DEVELOPMENT APPLICATION ASSESSMENT REPORT

Application Number:	DA2022/1474
Responsible Officer:	Kye Miles
Land to be developed (Address):	Lot B DP 393276, 14 Gladys Avenue FRENCHS FOREST NSW 2086 Lot A DP 393276, 12 Gladys Avenue FRENCHS FOREST NSW 2086
Proposed Development:	Demolition works, subdivision of two lots into four lots, including the construction of an access driveway, stormwater works, and the construction of four dwelling houses
Zoning:	Warringah LEP2011 - Land zoned R2 Low Density Residential
Development Permissible:	Yes
Existing Use Rights:	No
Consent Authority:	Northern Beaches Council
Delegation Level:	DDP
Land and Environment Court Action:	No
Owner:	Jian Zhang
Applicant:	Keeplan Pty Ltd
Application Lodged:	26/09/2022
Integrated Development:	No
Designated Development:	No
State Reporting Category:	Residential - New multi unit
Notified:	04/10/2022 to 18/10/2022
Advertised:	Not Advertised
Submissions Received:	6
Clause 4.6 Variation:	Nil

This application seeks approval for a torrens title subdivision into four (4) residential lots and the construction of four (4) dwellings.

Figure 1. Wall height non-compliance

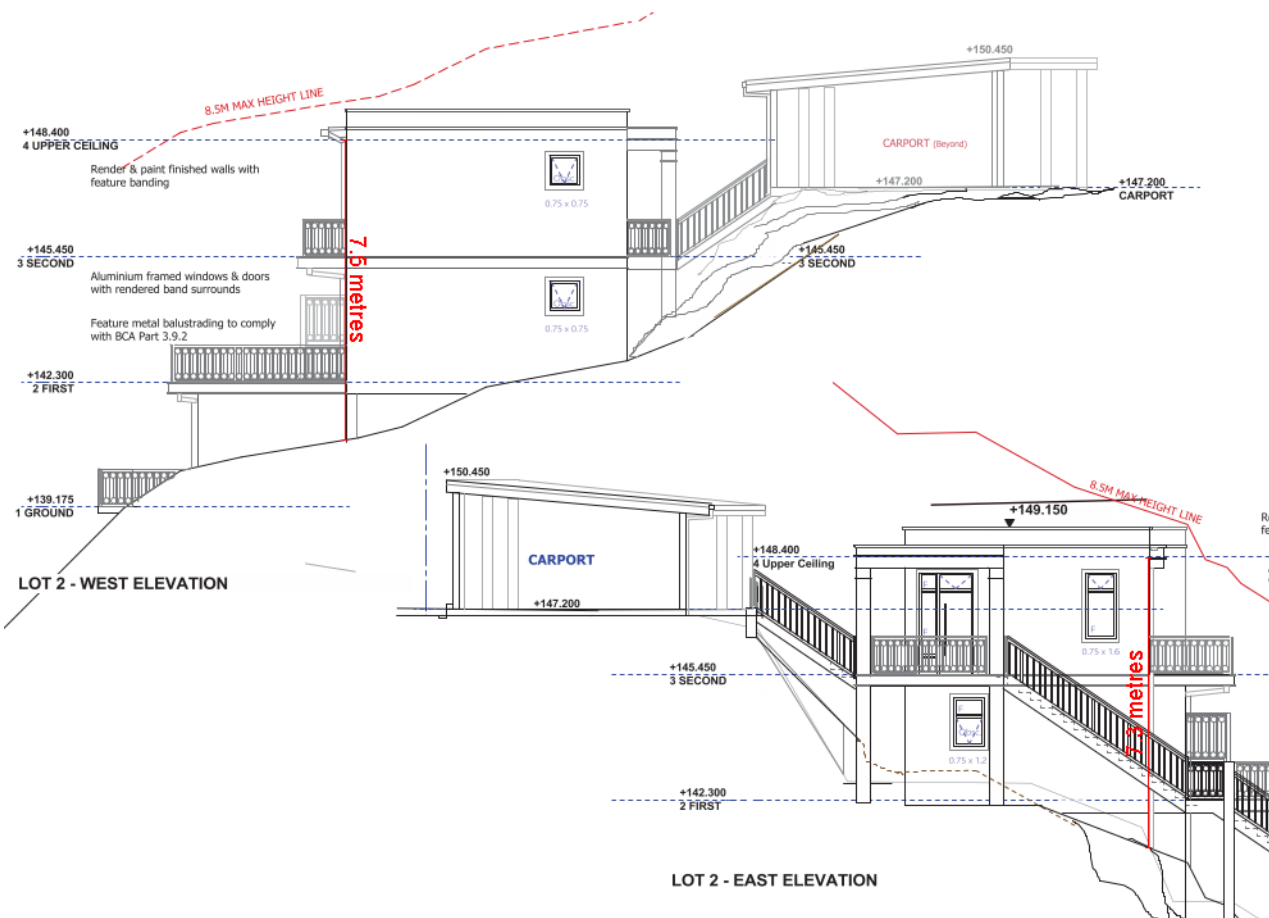
The control prescribes a maximum wall height in a continuous plane of 7.2 metres measured from existing ground level.

The non-compliance occurs along both elevations of the second floor, as indicated in the below diagram;

The proposed wall height breach is largely a consequence of site sloping to the north. Notwithstanding, the dwelling is located on a rear allotment of the proposed subdivision and is not readily visible from the public domain. Furthermore, suitable articulation is achieved using recessed and modulated walls, fenestration, balconies, eaves and changes in materials so as to provide visual relief to the second floor. In this regard, whilst the non-compliance would be visible from the adjoining properties, the scale of the wall is of such proportions that it would not create an unacceptable visual impact to those properties. Overall, the proposal remains consistent with the scale of development anticipated for the site and the development will not have an unreasonable visual impact when viewed from the streetscape and surrounding properties.

Figure 3. No. 10 Gladys Avenue first floor bedroom balcony facing north, across the side boundary from a standing position. Note height poles are indicative of the dwelling proposed on Lot 4.

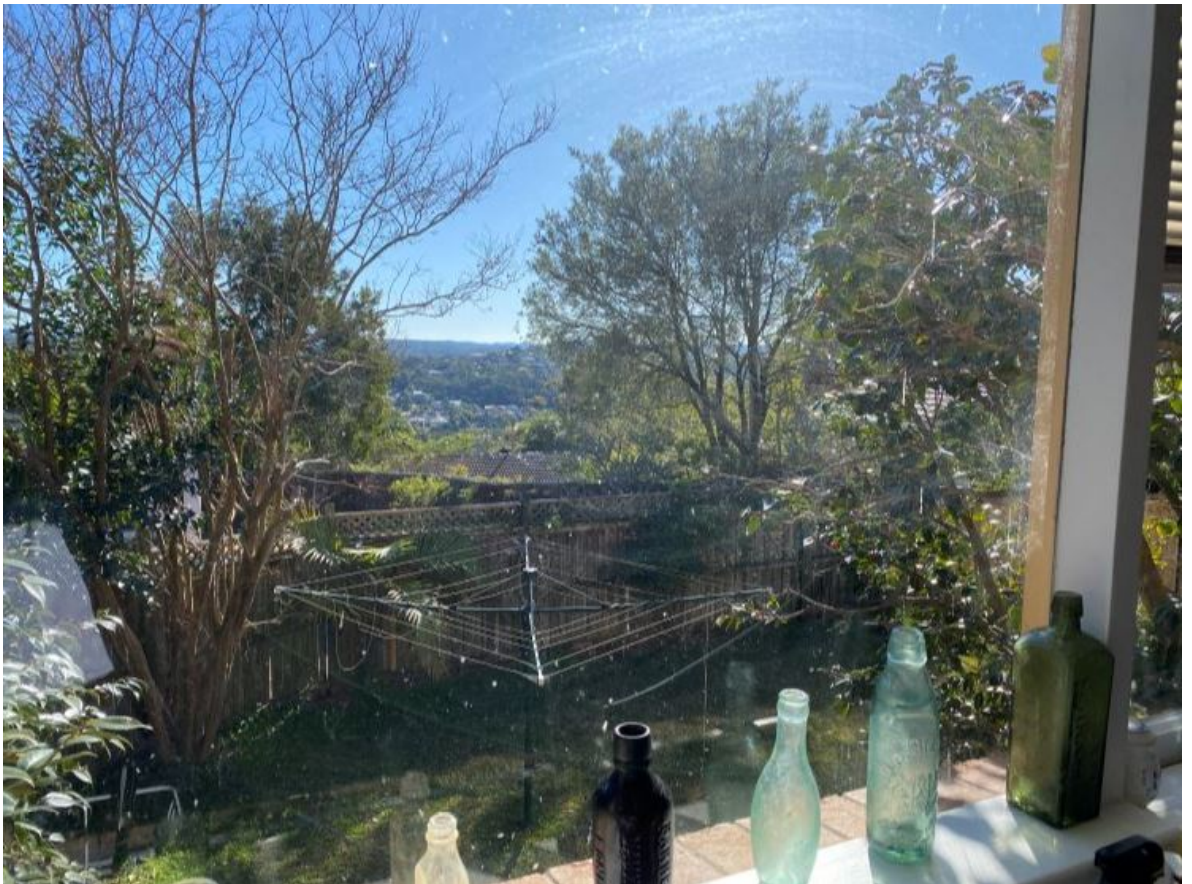
These properties adjoin the site to the south. The views affected are district views of trees and houses, which are generally obscured by existing canopy trees and existing residential development in the foreground. They are not considered highly valuable views in the context of these principles.
